## ADDENDUM NUMBER 3

**1.01 DATE: MARCH 24, 2021**

**1.02 PROJECT: WELCOME CENTER**

**1.03 PROJECT NUMBER: DCM NO. 2020604**

**4.05 SHEET P-1.1 – PLUMBING FLOOR PLAN – FIRST FLOOR:**

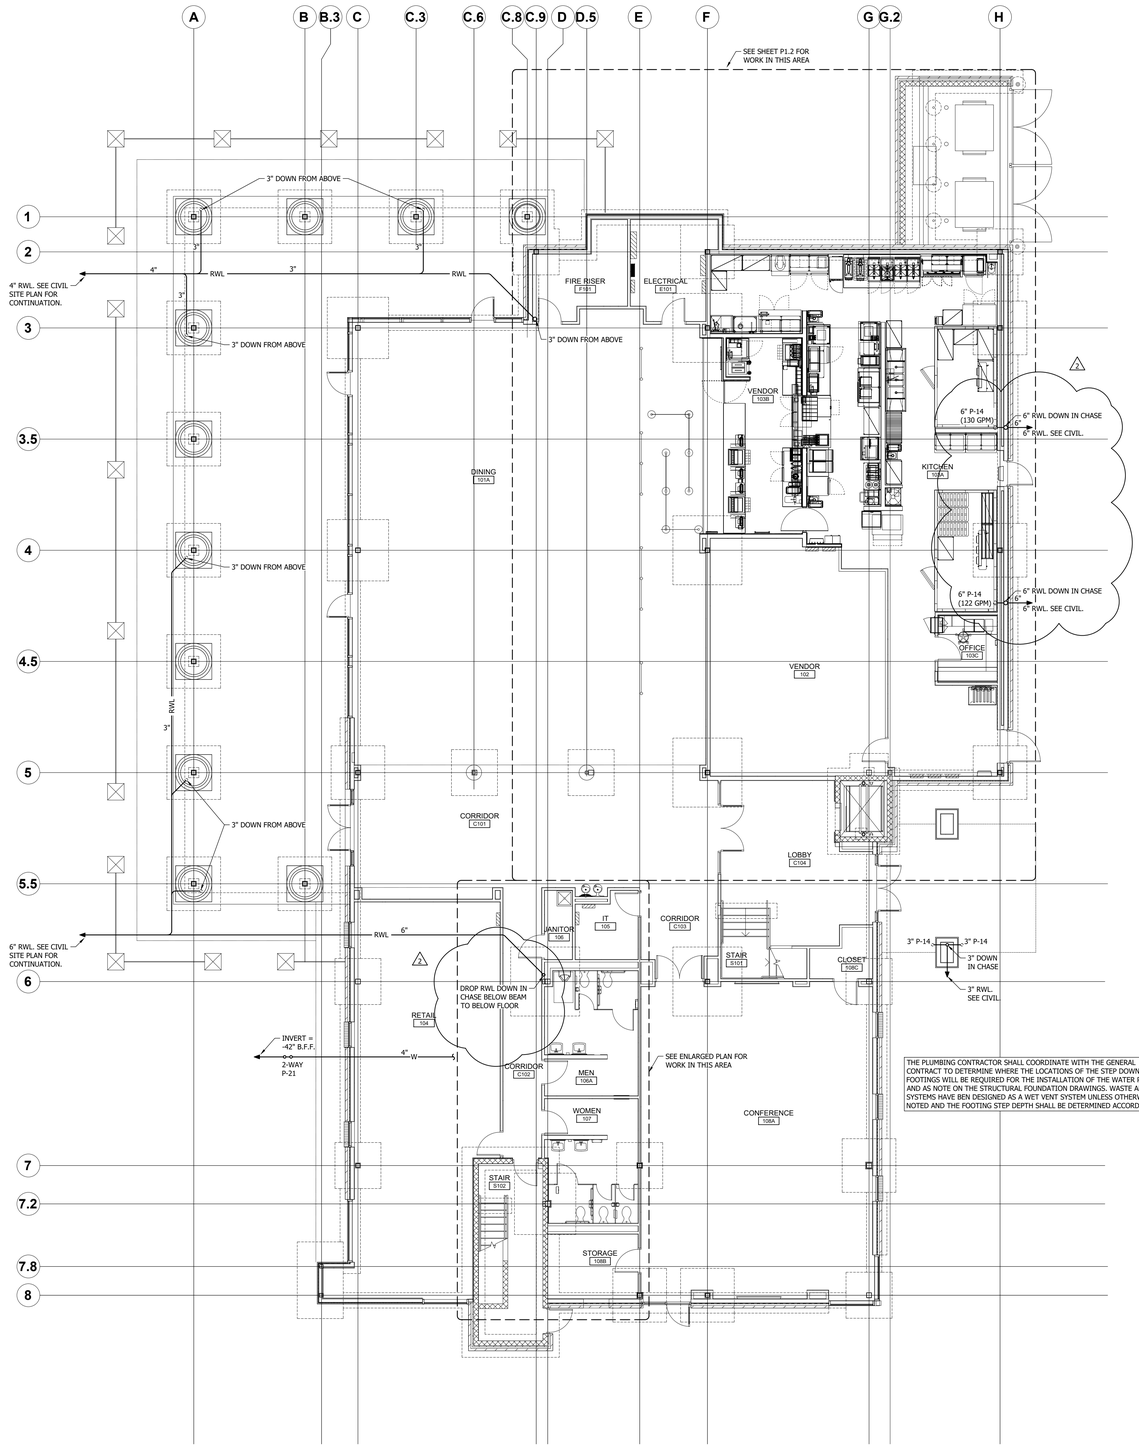
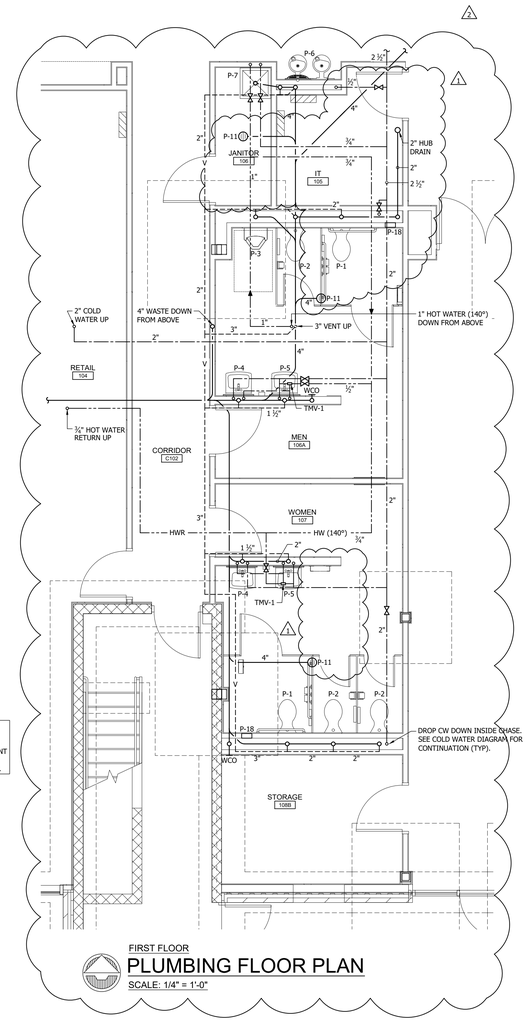
A. Replace this sheet in its entirety. Revisions include the following:
   1. Trap primers and drains have been removed from the floor plan.
   2. Floor drains labeled P-13 in Janitor 106, Men 106A and Women 107 have been changed to P-11.
   3. P-18 Interior Wall Hydrants have been added to the ADA stalls in Men 106A and Women 107.
   4. Roof drains, overflow drains and discharge nozzles have been changed to the appropriate fixture number, matching the roof plan.
   5. Vent systems have been added to the floor plan.
   6. The RWL dropping at CL 5.5 / D has been noted to dropping down to below floor.
   7. The HWR pipe note has been changed to hot water return up, in lieu of hot water return down.
   8. Added note to the cold water drop down in chase, to see Cold Water Diagrams for continuation (Typ.)

**4.06 SHEET P-1.2 – PLUMBING FLOOR PLAN – FIRST FLOOR KITCHEN:**

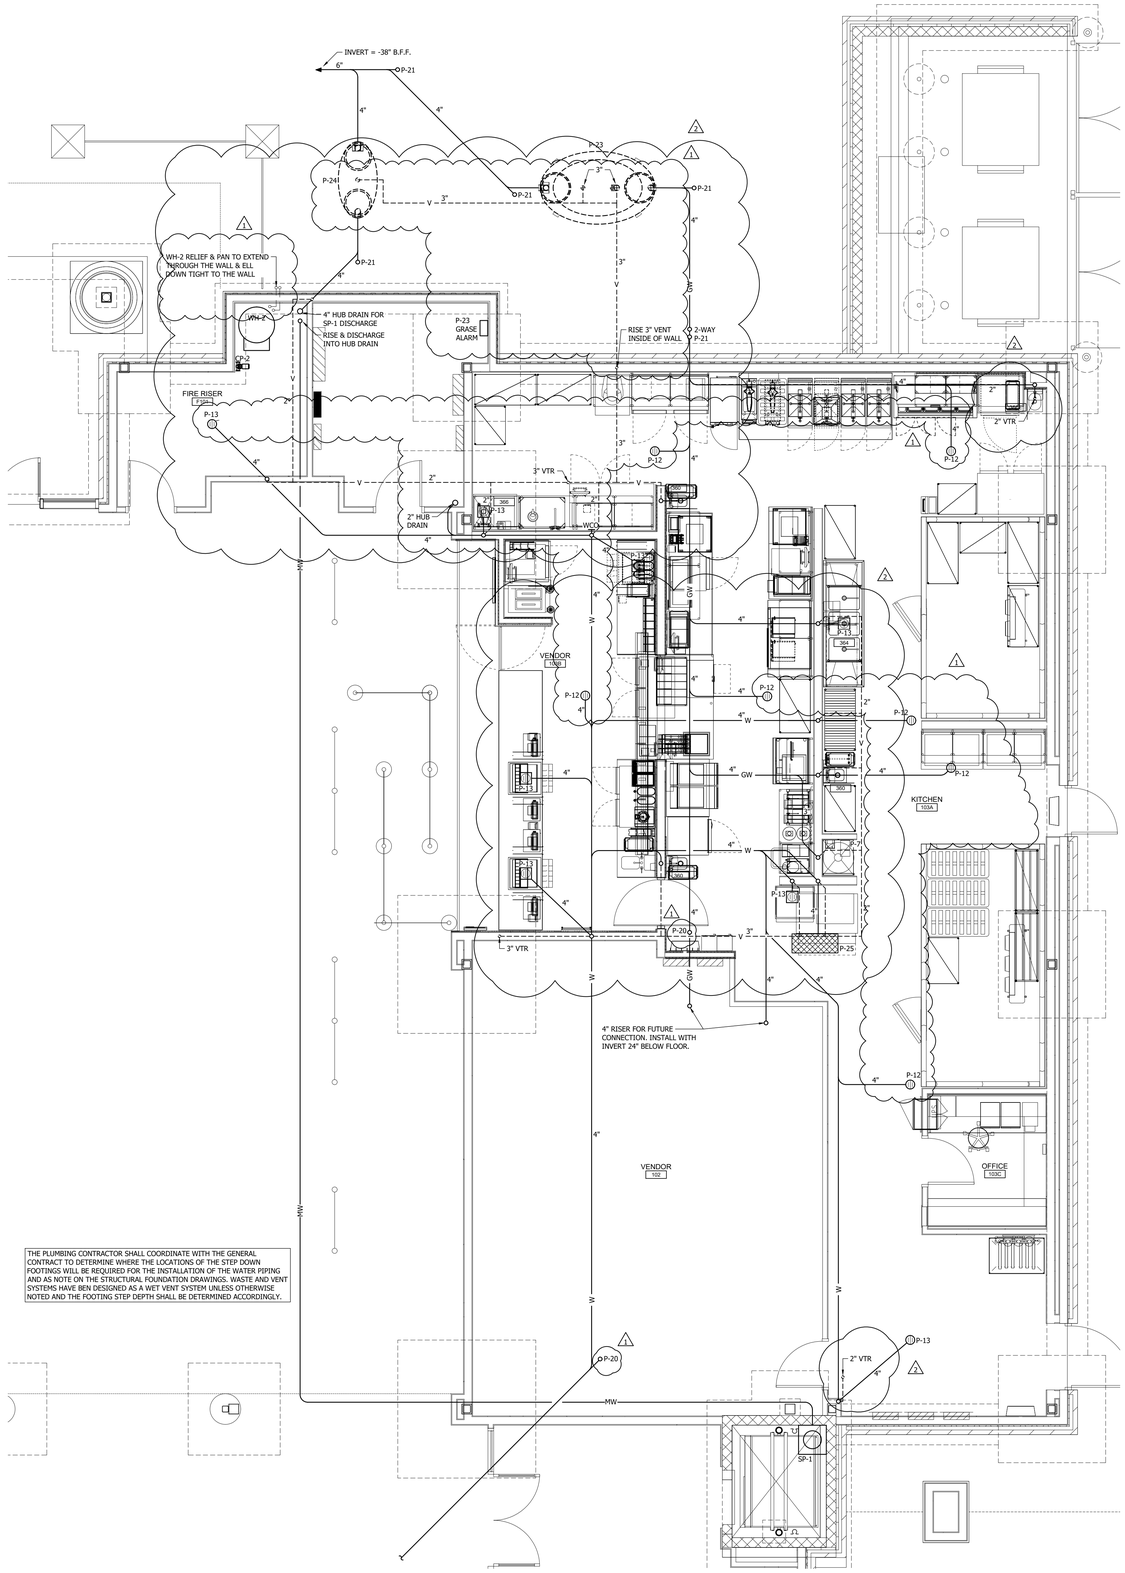
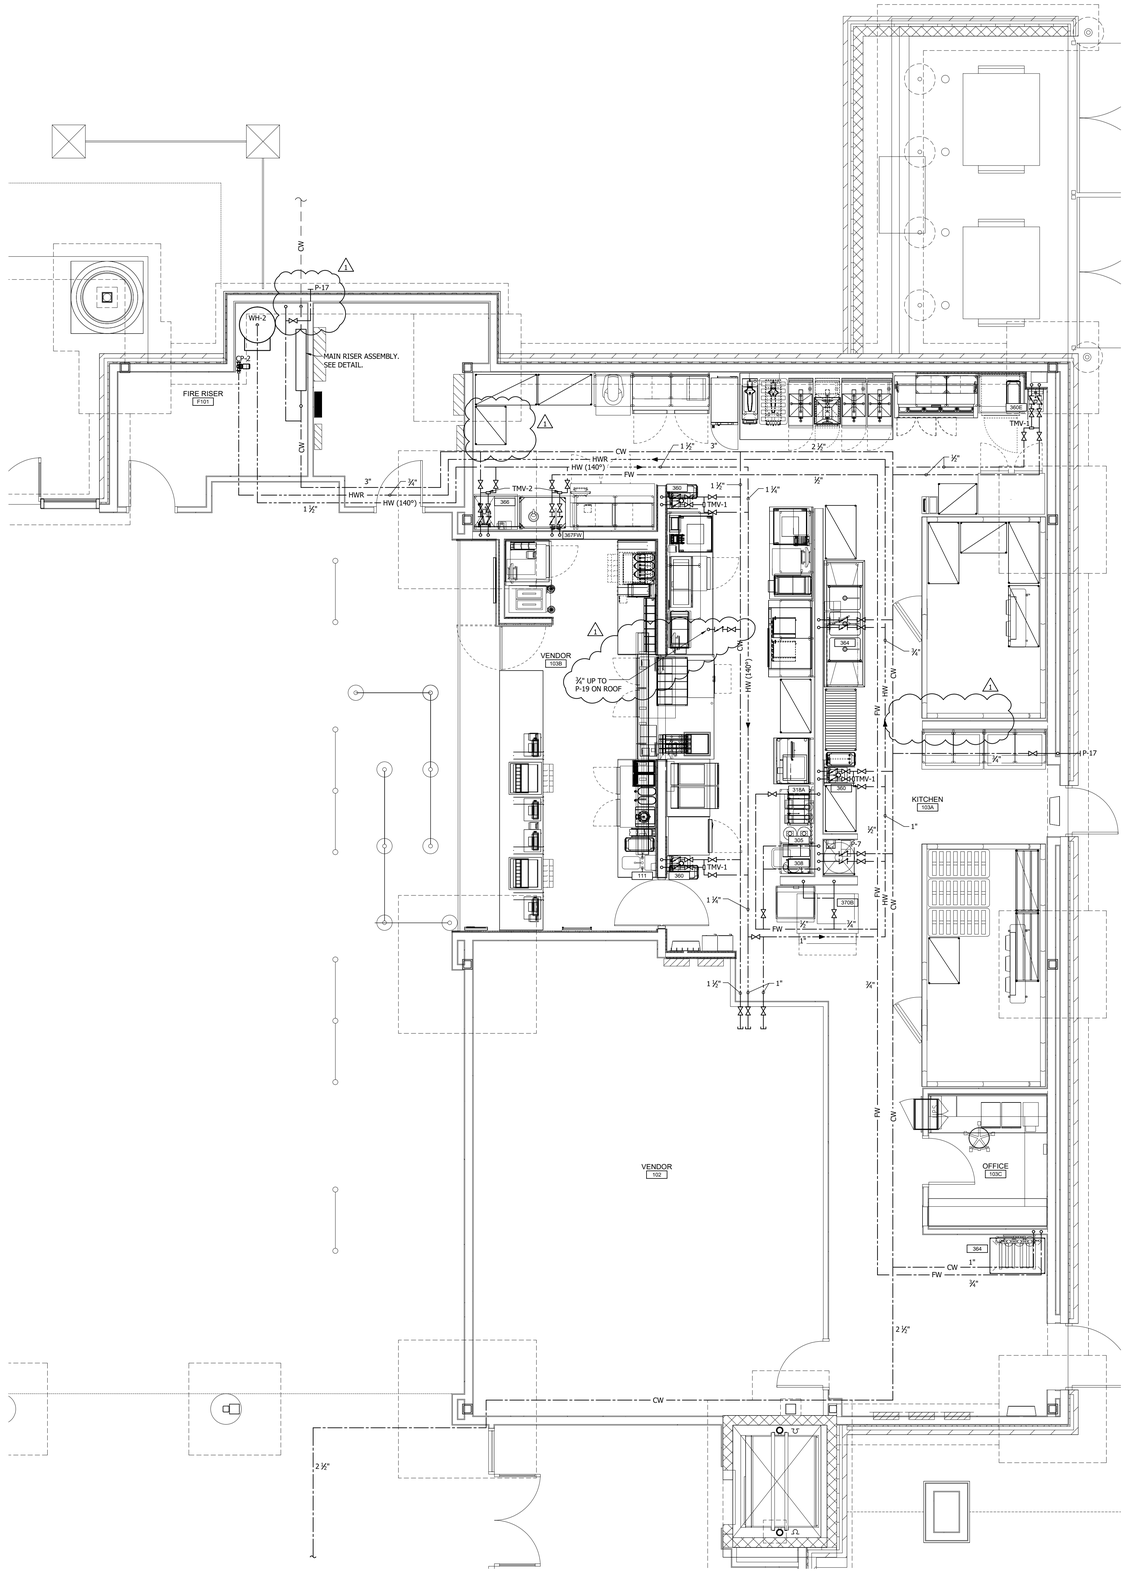
A. Replace this sheet in its entirety. Revisions include the following:
   1. Trap primers and drains have been removed from the floor plan.
   2. Vent systems have been added to the floor plan.

**4.07 SHEET P-1.3 – PLUMBING FLOOR PLAN – SECOND FLOOR:**

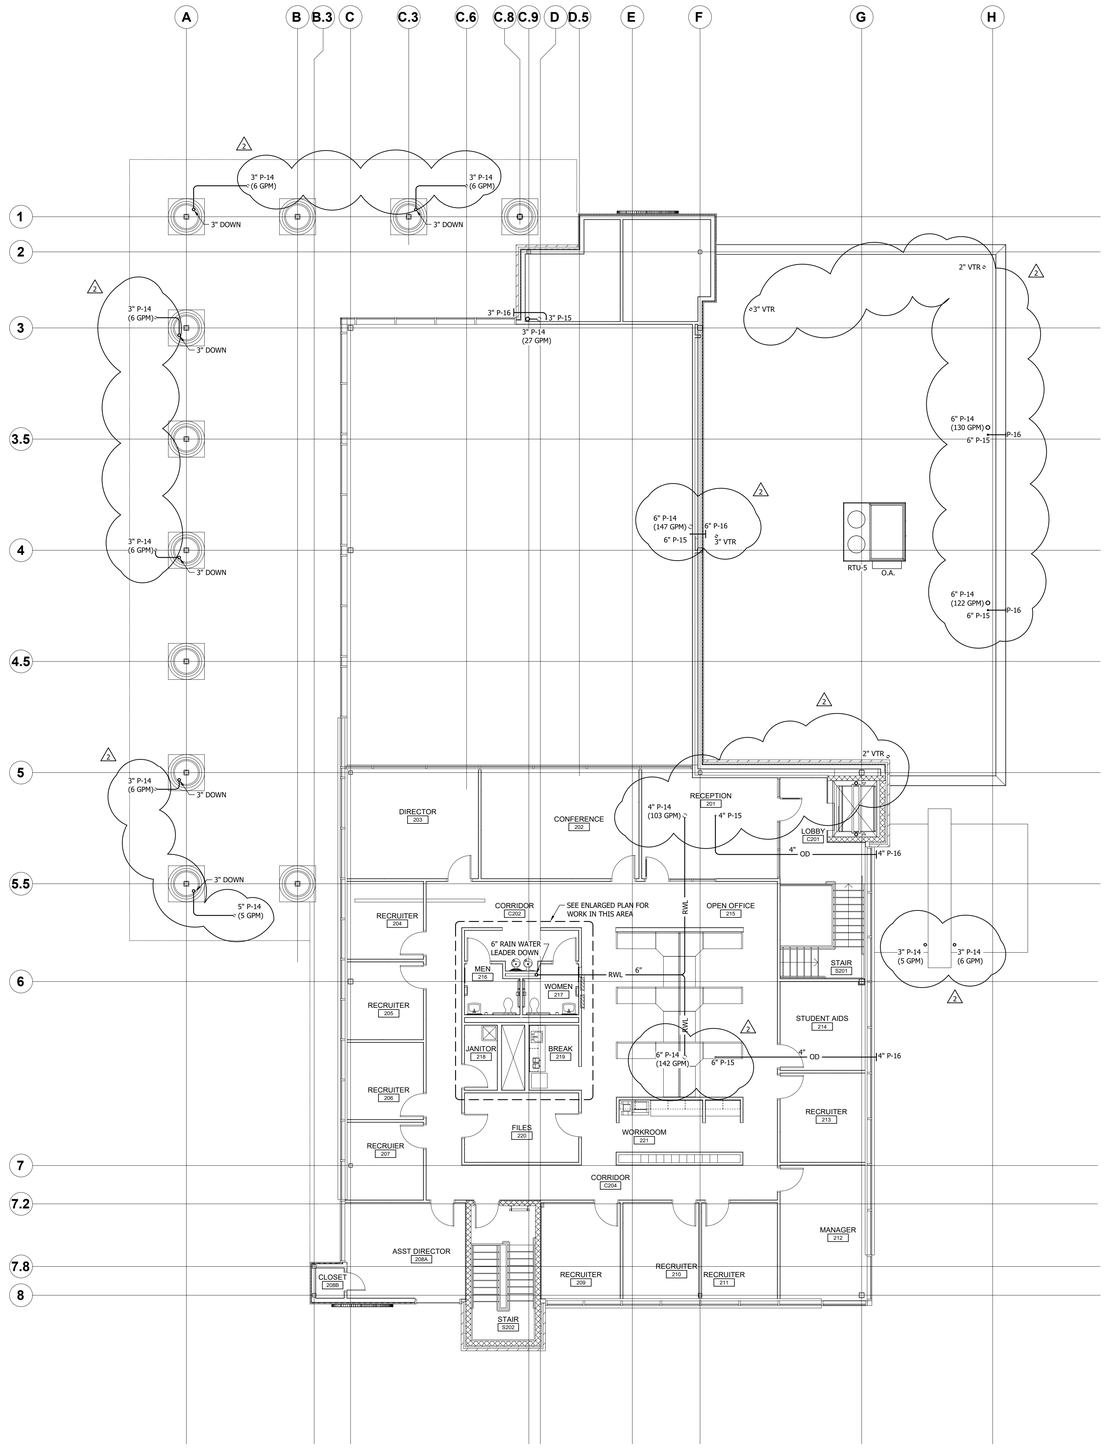
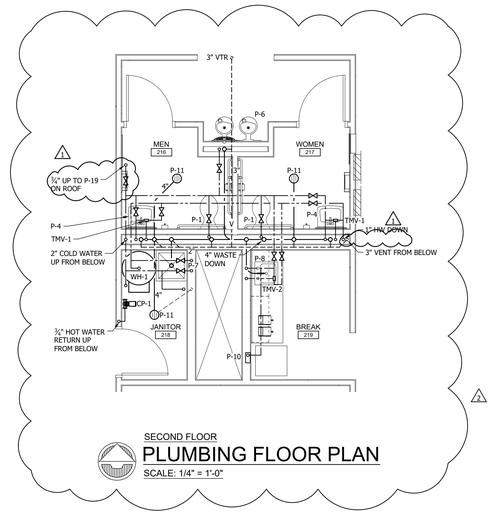
A. Replace this sheet in its entirety. Revisions include the following:
   1. Trap primers and drains have been removed from the floor plan.
   2. Vent systems have been added to the floor plan.
   3. Plumbing VTR’s have been shown on the low roof, including the mechanical units, for compliance of the 15’ minimum between the vents and the unit outside air intake hoods.
   4. The water closet in Women 217 has been changed to a P-1 fixture.
   5. All roof drains and overflow drains have been changed to fixture number and size.
   6. The overflow drains off the kitchen roof has been changed to show the drain routing and P-16 discharge nozzle.

**4.08 SHEET P-1.4 – PLUMBING FLOOR PLAN – ROOF:**

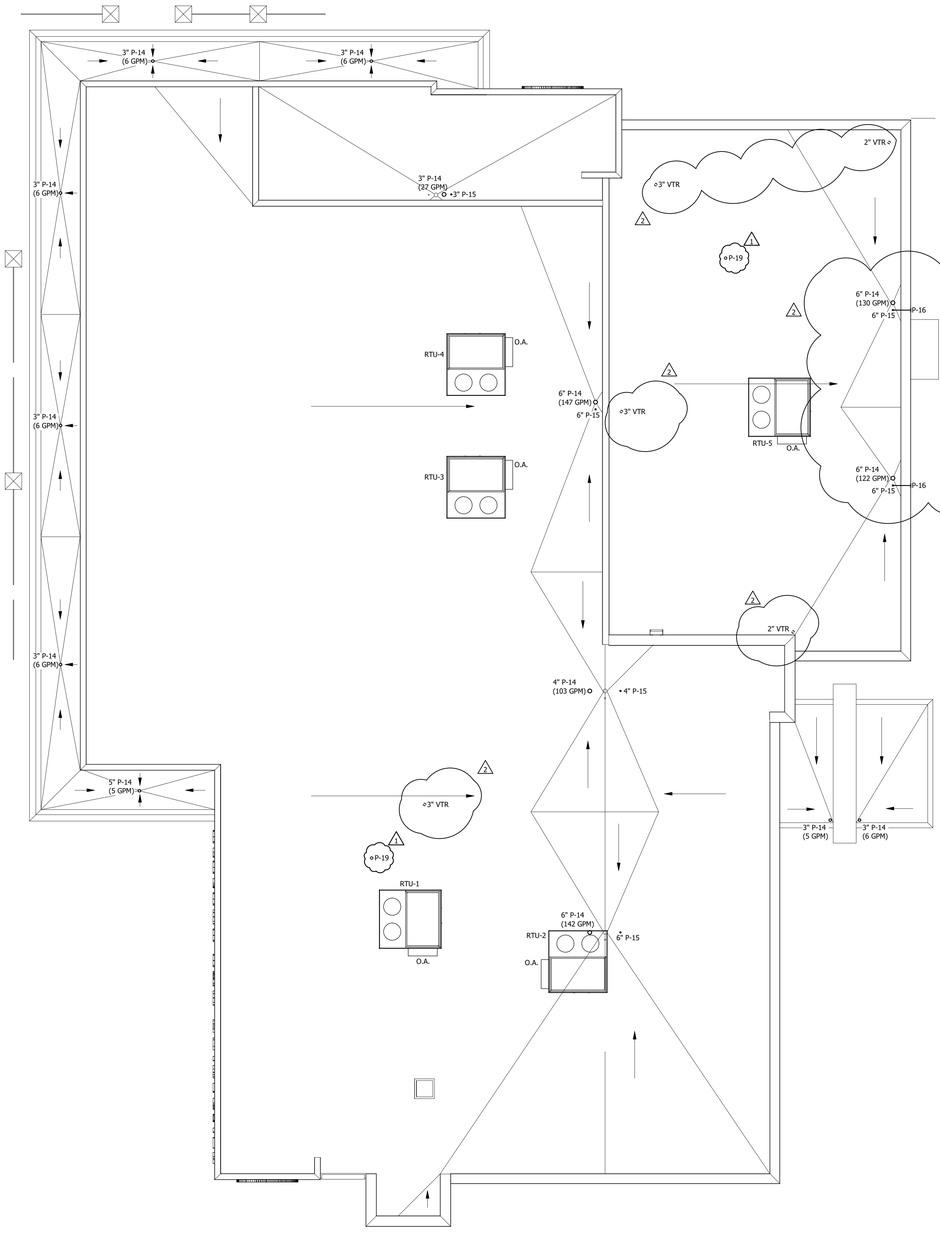
A. Replace this sheet in its entirety. Revisions include the following:
   1. Plumbing VTR’s have been shown on the low and high roof, including the mechanical units, for compliance of the 15’ minimum between the vents and the unit outside air intake hoods.

**4.10 SHEET P-2.2 – HOT WATER DETAILS & RISER DIAGRAM:**

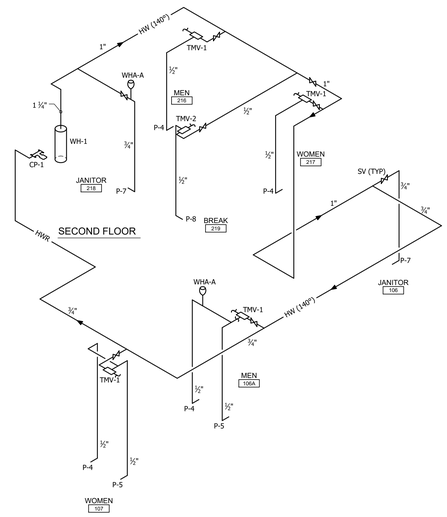
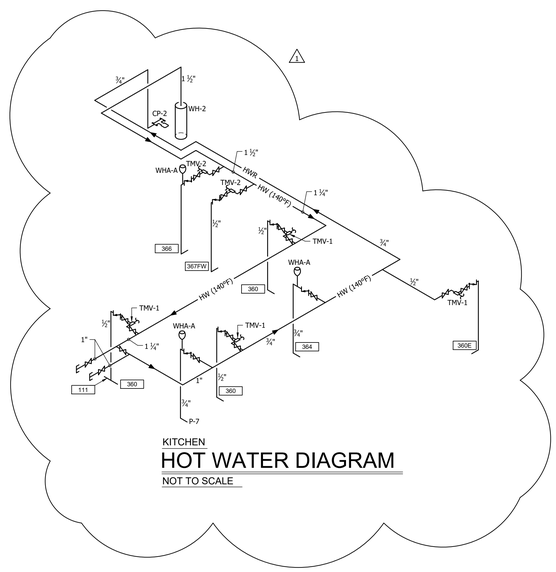
A. Replace this sheet in its entirety. Revisions include the following:
   1. A check valve has been added to the Circulation Pump Detail and both Water Heater Details.

**4.11 SHEET P-2.3– COLD WATER DETAILS & RISER DIAGRAM:**

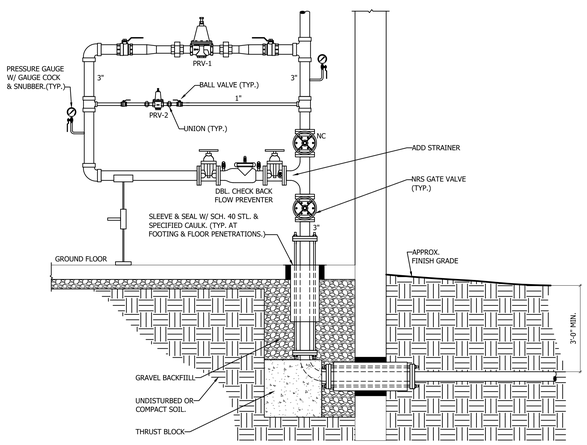
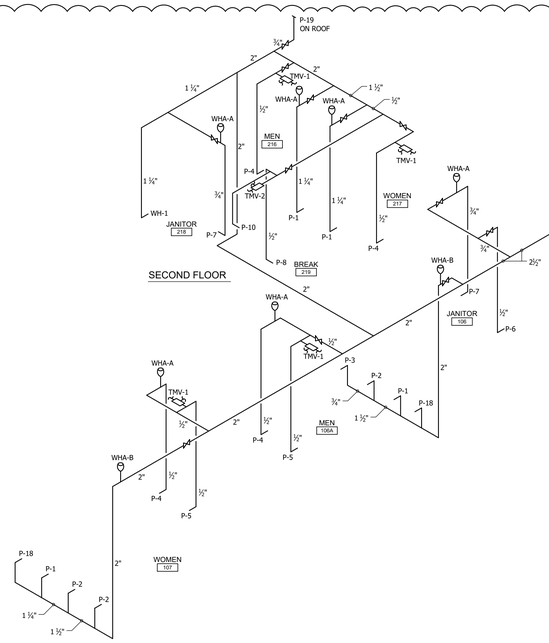
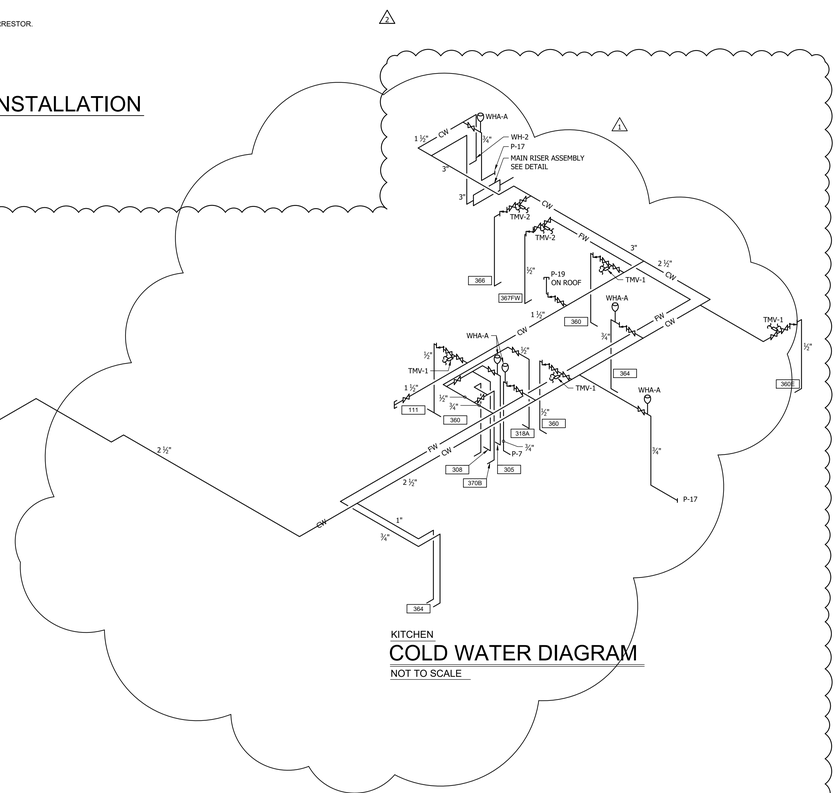
A. Replace this sheet in its entirety. Revisions include the following:
   1. Kitchen Cold Water Diagram has been connected to the other cold-water diagram.
   2. P-18 Interior Wall Hydrants have been added to Toilets 106A and 107.
